# Stage 3 Facilities, Sydney Business Park **Supplementary Response to Submissions**

PJEP Ref: Supplementary RTS\_Dec20

Marsden Park Developments Pty Ltd (Sydney Business Park) is proposing to develop four world-class warehouse and distribution facilities in the 'Stage 3' area of Sydney Business Park, within the Marsden Park Industrial Precinct in Western Sydney.

This Supplementary Response to Submissions (Supplementary RTS) document has been prepared by PJEP Environmental Planning Pty Ltd (PJEP) to provide a response to residual issues raised in additional submissions provided by government agencies.

**Figure 1: Additional Intersection Upgrades (Source: Arup)**

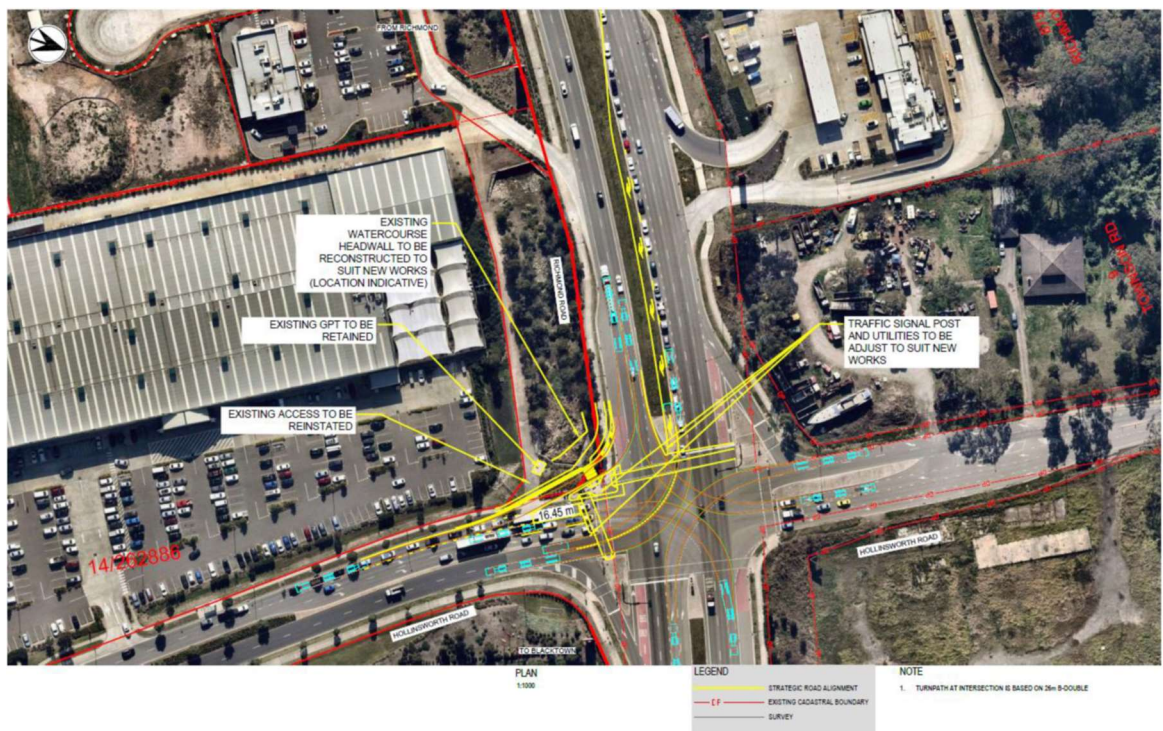
The key outcome of this meeting was that TfNSW requested Sydney Business Park to consider additional upgrades to the Richmond Road/Hollinsworth Road intersection, and provide additional modelling to assess whether such upgrades would improve the performance of the intersection.

Notwithstanding, Sydney Business Park's traffic consultant, Arup, has undertaken further analysis of the benefits of the addition of a left turn slip lane from Hollinsworth Road into Richmond Road, and an additional right turn lane from Richmond Road into Hollinsworth Road.

The additional assessment and intersection modelling results are attached in **Appendix F**, and the conceptual road upgrade works are shown on **Figures 1 and 2**.

The intersection modelling indicates that the left slip lane and right turn lane, with the proposed development, would maintain the current level of service at the Richmond Road/Hollinsworth Road intersection for all turn movements (see **Appendix F**).

Whilst Sydney Business Park maintains that the traffic generation associated with the development is consistent with the estate planning, it has offered to forward fund the design and construction of additional upgrade works (ie. the left slip lane and right turn lane) on behalf of TfNSW.

Figure 4: Stage 3 Master Plan, as revised (Source: Reid Campbell)

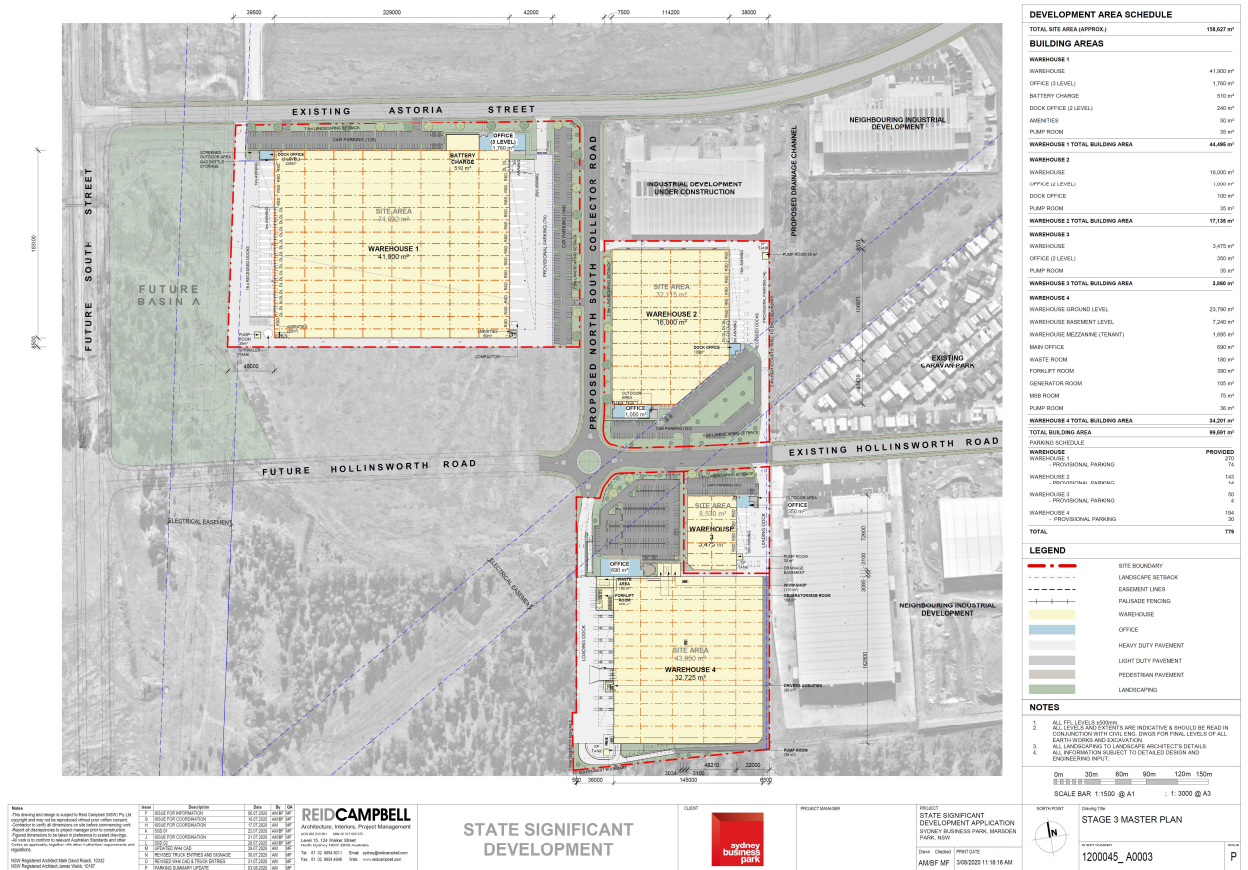
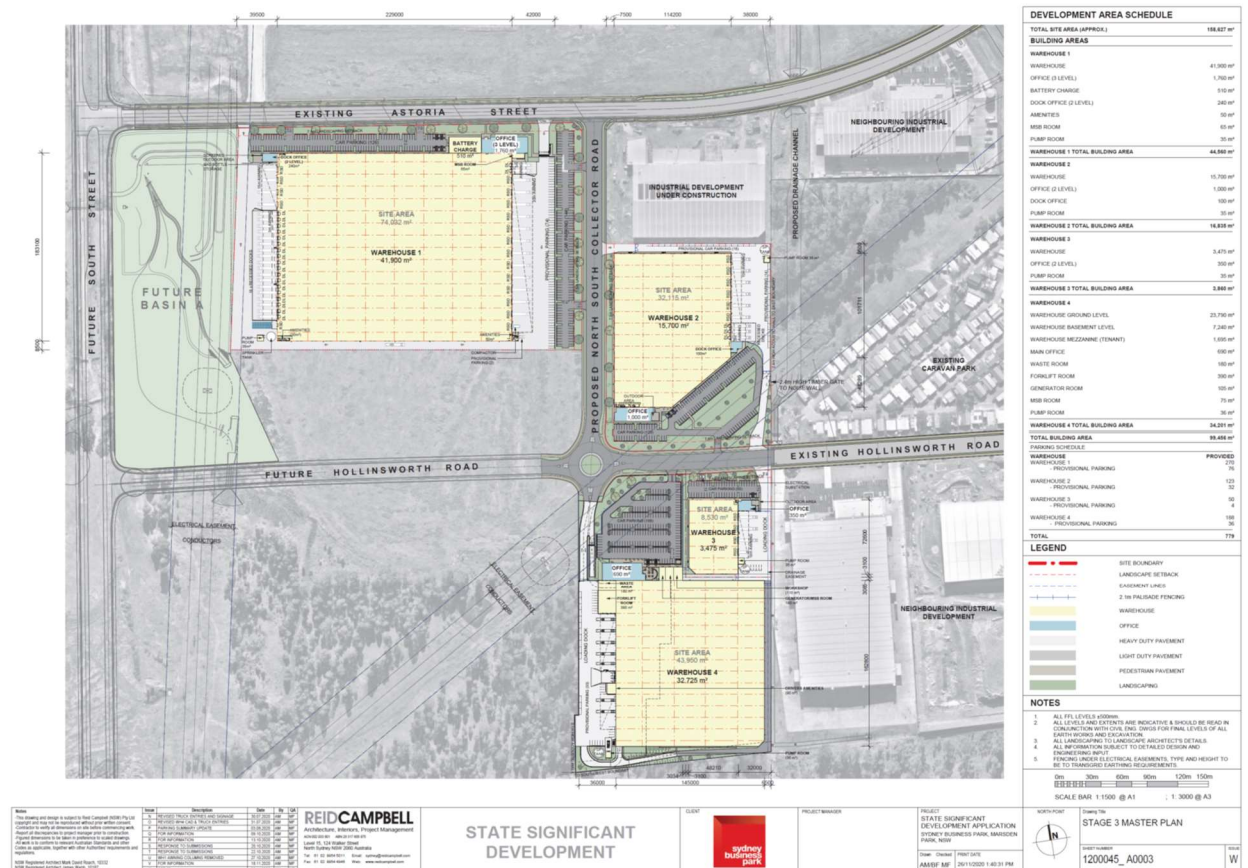
- changes to the carparks in Warehouse 2 and Warehouse 4 to remove parking spaces from the central corridor of the electricity easement, to address TransGrid's recommendations;

- relocation of the driveway to the Warehouse 2 carpark from the central corridor of the electricity easement, to address TransGrid's recommendations;
- a small reduction (ie. 300 m<sup>2</sup>) in the area of Warehouse 2, and removal of one recessed dock, as a result of the changes to the carpark to meet TransGrid's recommendations;

- relocation of the bicycle parking area in Warehouse 4 from below the central corridor of the TransGrid easement, to the south-eastern corner of the carpark, to address TransGrid recommendations;

- relocation of the electrical kiosk substations from Warehouse 4 to Warehouse 3, to provide additional parking spaces for Warehouse 4 and address Endeavour Energy comments about risks associated with the substations near the Warehouse 4 Facility;

- switching the positions of Signs 2 and 3 in Warehouse 4, to move the taller Sign 2 out of the central corridor of the TransGrid easement;
- additional landscaping within the site to increase the amount of shading to the hardstand areas; and

A comparison of the Stage 3 Master Plan as originally proposed in the EIS, and as revised in this Supplementary RTS, is shown on **Figures 3** and **4** below. As illustrated, the changes to the proposed development are minor in nature.

None of the minor amendments would adversely affect the environmental impacts of the development as assessed in the EIS and this RTS, and the development as amended is substantially the same development as proposed in the original development application. The amendments arise as a direct result of addressing the issues raised in submissions.
